**TOWN OF HERNDON, VIRGINIA
HISTORIC DISTRICT REVIEW BOARD
VIRTUAL WORK SESSION AGENDA
JANUARY 6, 2021
HERNDON COUNCIL CHAMBERS BUILDING
765 LYNN STREET
7:00 P.M.**

Title: HDRB #21-001; New Construction – 647 Jefferson St.

Summary Information

Applicant Request	New construction of a single-family detached residential dwelling with attached garage		
Address	647 Jefferson St, Station House; Downtown Herndon		
Fairfax County Tax Map Number	0162-53-0002		
Applicant/Owner	Station House, LLC c/o Stephanie Wright		
Agent	N/A		
Business/Organization	N/A		
Property Use	Single-family residential		
Zoning District	PD-TD, Planned Development – Traditional Downtown		
Parcel Size	4,926 square feet; 0 .113 acres		
HDO Designation	Non-contributing		
Adjacent Zoning	North: R-10, Residential, Single-family South: CS, Commercial Service	East: PD-TD, Planned Development – Traditional Downtown West: PD-TD, Planned Development – Traditional Downtown	
Adjacent Property HDO Designations	North: Contributing South: N/A	East: Contributing West: Noncontributing	
Associated Cases	ZMA #14-103; TP #17-10; HDRB #21-002		
Building Type(s)	Two-story residential	Date of Construction:	N/A

The Station @ Lot 2 Jefferson Street by Elevations

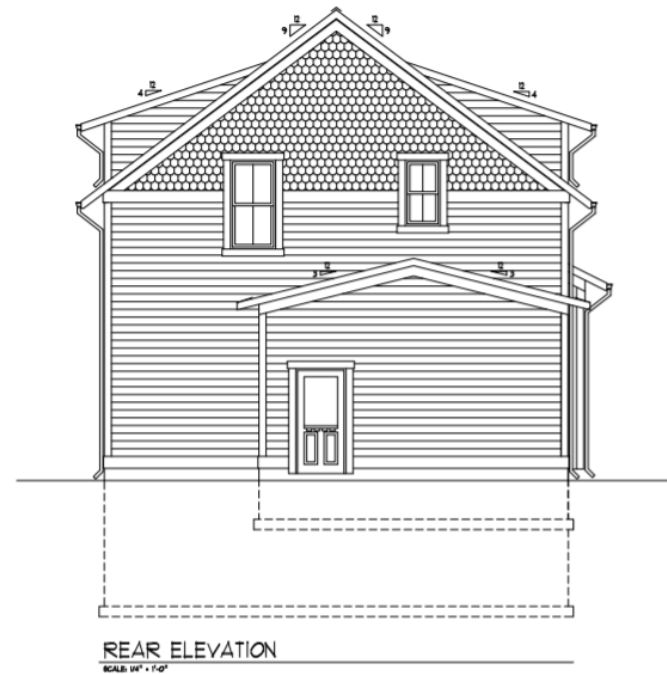
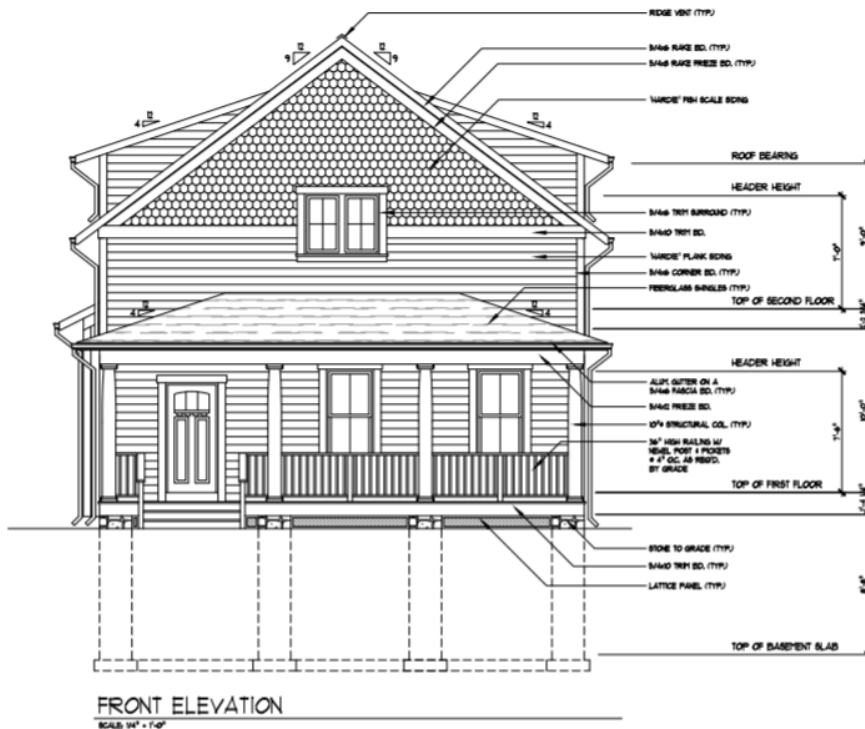
Staff finds that these details need to be clarified and depicted accurately in all elevations and written descriptions such that the staff and Board can complete a full review of the project. Accordingly, staff is cannot provide a recommendation until these detail and material issues are resolved. Staff also recommends that these items be discussed in light of the stylistic comments provided by staff in comment #2 above.

As proposed for vinyl windows in this case, staff finds that wood or aluminum clad wood windows would be the most appropriate window material types. In addition, the guidelines recommend that windows be horizontally and vertically aligned. The proposed design has virtually no vertically aligned windows and sparingly few horizontal alignments on each floor. This issue was specifically raised by the HDRB in its review of the General Development Plan architectural component of ZMA #14-103 (Attachment #6).

7. The design qualities of any exterior materials, such as siding profile, should reflect the architectural style of the house.	The main cladding material and profile is with Hardieplank® lap siding with 6" reveals and, 1" flat relief between courses that is consistent with the Craftsman style, though a common modern material is used. However, as noted in the staff report, the fish-scale or scalloped profile under the front facing gable roof form is not appropriate. Staff has recommended the use of a shake or half-timber profile in the accent application as an appropriate expression of the style using modern composite materials in order to fully conform to this guideline.
Choosing the Exterior Materials:	1. Materials selected should be consistent with the architectural style of the structure.	The primary cladding materials and horizontal siding profile is indicative of a modern expression of the Craftsman style. In many cases, the trim features are not detailed with the specific materials and profiles making part of the evaluation of these features inconclusive and incomplete.

The Station @ Lot 1 Jefferson Street by Elevations

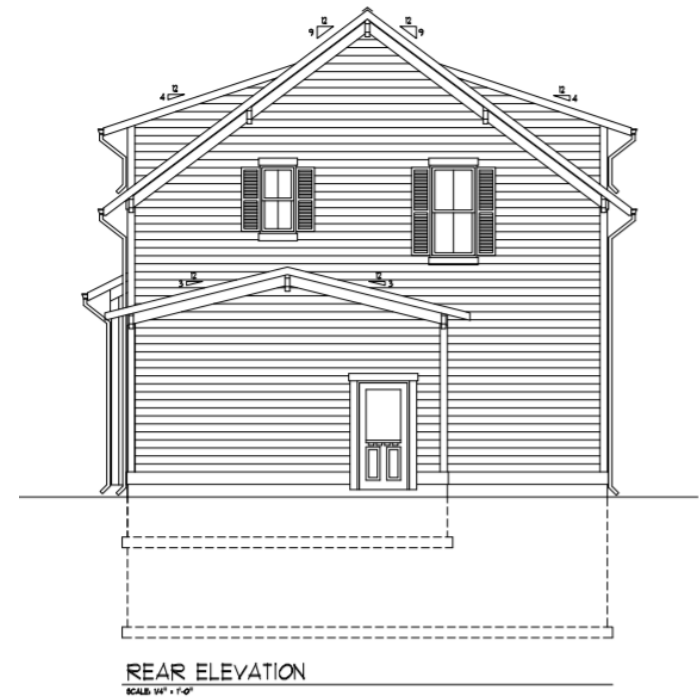
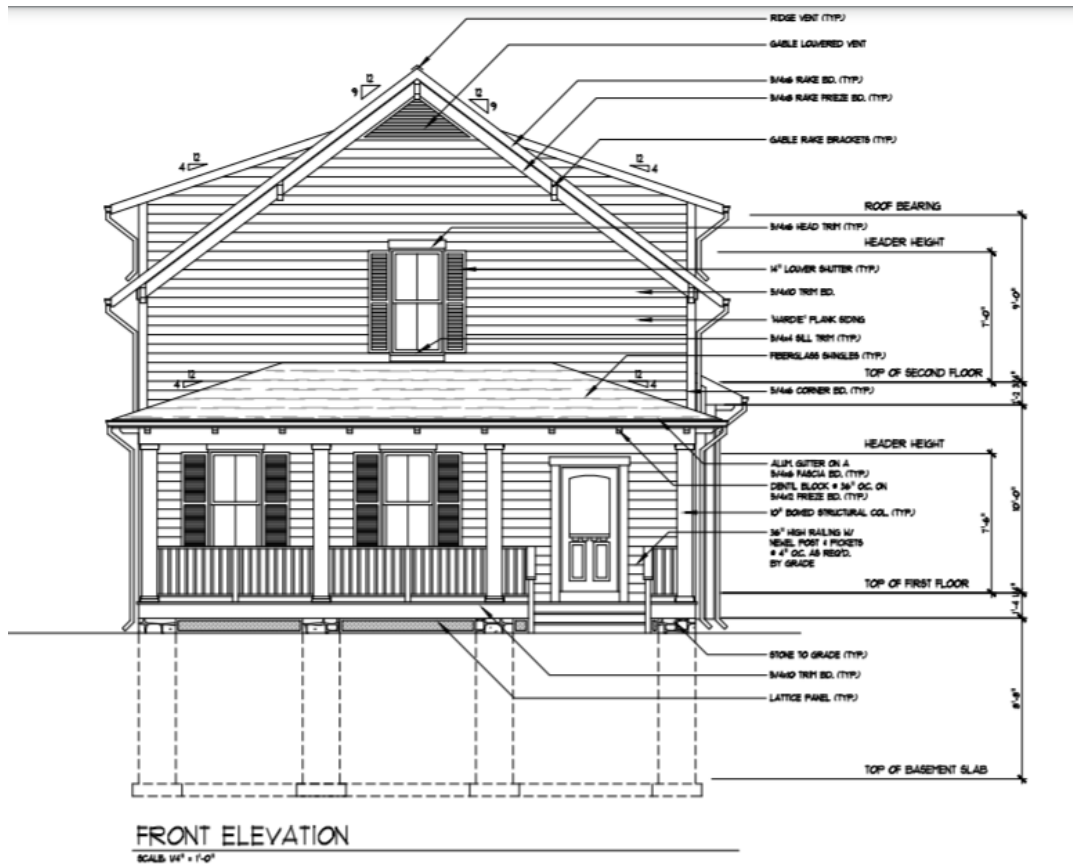
Staff finds that these details need to be clarified and depicted accurately in all elevations and written descriptions such that the staff and Board can complete a full review of the project. Accordingly, staff is cannot provide a recommendation until these detail and material issues are resolved. Staff also recommends that these items be discussed in light of the stylistic comments provided by staff in comment #2 above.

As proposed for vinyl windows in this case, staff finds that wood or aluminum clad wood windows would be the most appropriate window material types. In addition, the guidelines recommend that windows be horizontally and vertically aligned. The proposed design has virtually no vertically aligned windows and sparingly few horizontal alignments on each floor. This issue was specifically raised by the HDRB in its review of the General Development Plan architectural component of ZMA #14-103 (Attachment #6).
